GFA AIRWORTHINESS DIRECTIVE

- TYPE AFFECTED:** SZD-50-3 PUCHACZ. ALL SERIAL NO'S.
- SUBJECT:** Failure of Pushrod End Bearing in elevator circuit.
- BACKGROUND:** A failure occurred in the elevator control circuit which resulted in total loss of elevator control from the front cockpit. Fortunately the aircraft was being flown dual and the rear pilot landed the glider safely. Had the failure occurred during solo flight or with an inexperienced person in the rear the outcome could have been serious indeed.

SZD-50-3 PUCHACZ AD-623

Broken rod end bearing showing extent of bending prior to failure. Note profile of locktab to suit keyway.

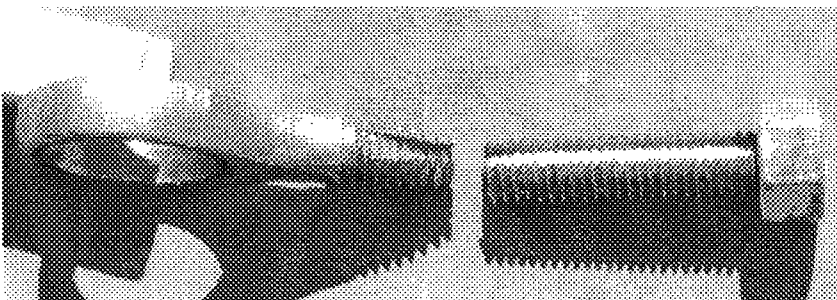
- FINDINGS:** On inspection it was found that the rear rod end bearing of the elevator pushrod which connects the front and rear control columns had broken at the point where the threaded portion enters the locknut. The pushrod was therefore completely detached from the rear stick.

- Continuing investigations indicate that the end bearing which failed was mechanically damaged well prior to the failure, and although not yet positively established, it is believed that the end bearing was bent by a person treading on the push rod or end bearing while entering or exiting the rear cockpit; not by loads imposed during flight.

- Accordingly, Issue 2 of this AD removes the requirement to disassemble all pushrod ends which have a keyway cut into the threaded portion (Item 3 of Action A, Issue 1). Metallurgy tests of the broken rod end are still underway.

- ACTION REQUIRED:** **"ACTION A": Before further flight** the following checks must be performed.
1. The pushrod connecting the front & rear control columns is to be examined critically. This is the pushrod which runs down the left side of the cockpit. Remove the rear rod end from the pushrod and inspect the threaded area for bending or cracks using a 10X magnifier.

3. Visually inspect all other rod ends in the control circuits for any sign of bending in the threaded area. The positions of any rod ends with a keyway are to be noted and their locations advised to GFA.

4. Any suspect rod ends must be replaced with serviceable components before further flight.

View looking vertically downwards, left side of rear cockpit floor, showing edge of rear control column cross member and rear end of the elevator pushrod where the rod end bearing failed. Locknut and tab washer are still in place. Trim knob is visible in upper left of picture.

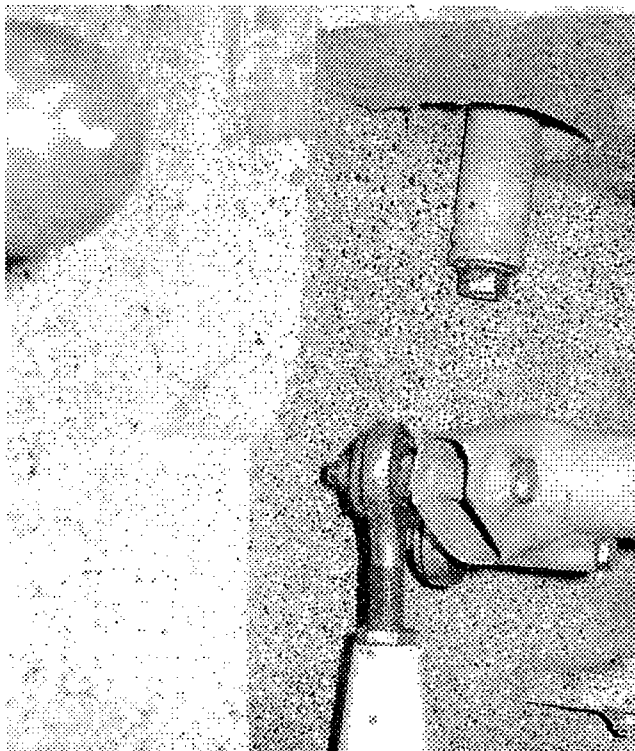
The rear end of the elevator pushrod which connects the front and rear control columns is to be visually inspected for any sign of bending in the rod or the end bearing. If damage is suspected carry out item 4 of “Action A”.

"Action B" of the above AD requires that the elevator push rod located on the left side of the fuselage beneath the cockpit floor level be inspected for bending of the rod or rod end bearing as part of the DI. Normally this would require the removal of the rear seat pan. However a method has been devised whereby the continued straightness of the rod can be verified without the necessity to remove the rear seat.

Use a fine tip waterproof marker pen to make two reference lines on the left cockpit wall. This is achieved by using the pushrod as a guide and resting the marker pen on the pushrod but at right angles to it and drawing a line on the side of the fuselage. Draw two lines:- one above and one below the pushrod. The pushrod can then be "sighted" against these lines to check that it is still parallel to them. Any "Angle" visible between the lines and the pushrod will indicate it or the rod end may be damaged, in which case further disassembly would then be necessary.
